FCC Class II Permissive Change Request Letter

RE: FCC Permissive II Change Request for Company: HUIZHOU FORYOU GENERAL ELECTRONICS CO.,LTD.

FCC ID: 2AEIN-4154493C1

Add model: 4275486C1 based on the original project.

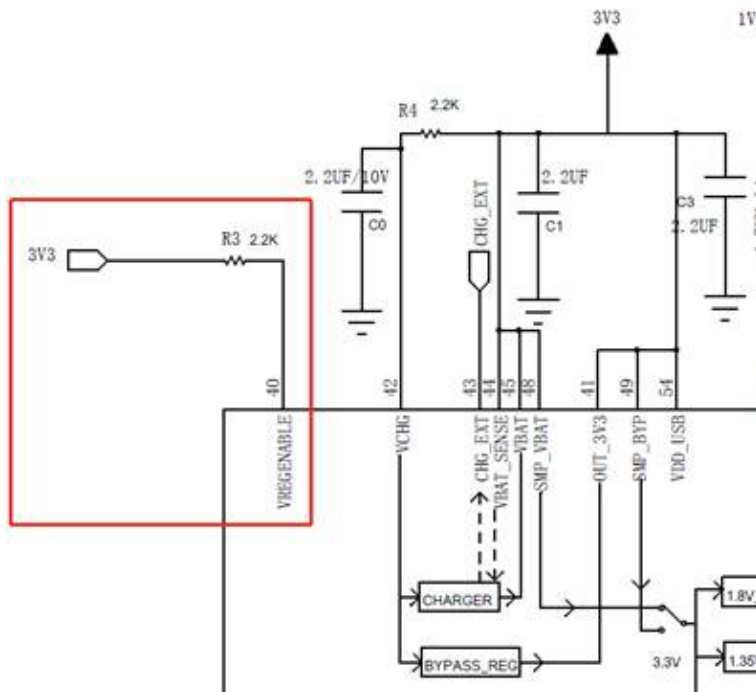
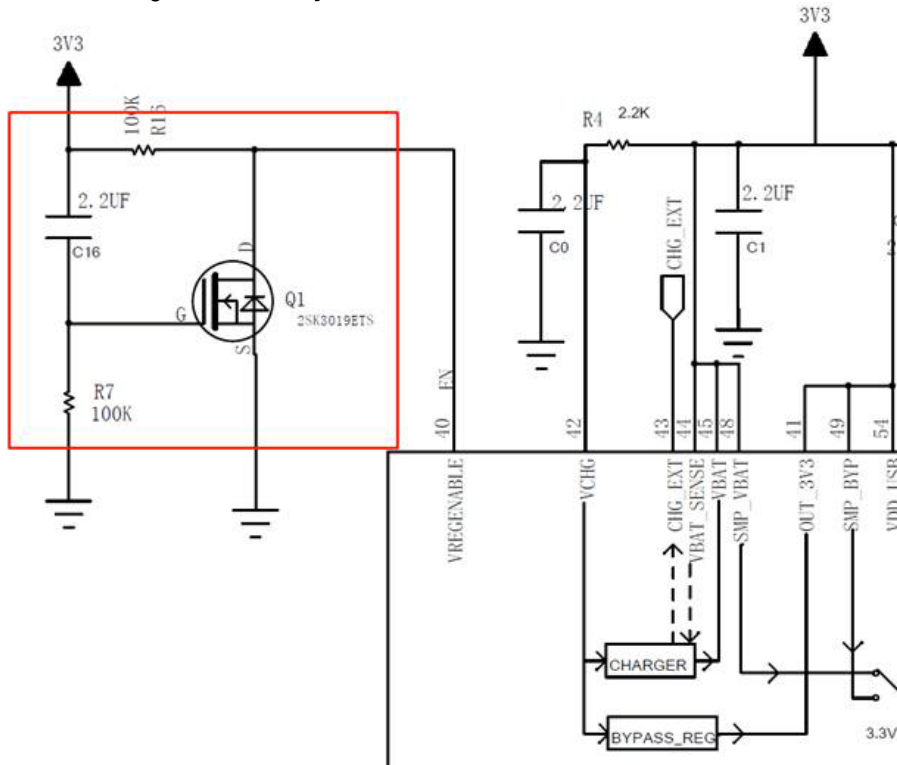
Compared with the model 4154493C1, the model 4275486C1 is canceled the DVD movement and DVD play function, add power amplifier and change a plate, canceled SXM function. The Bluetooth RF chip's power supply circuit add the delay circuit. RF parameters didn't change.

Before the change:

After the change: Add delay circuit
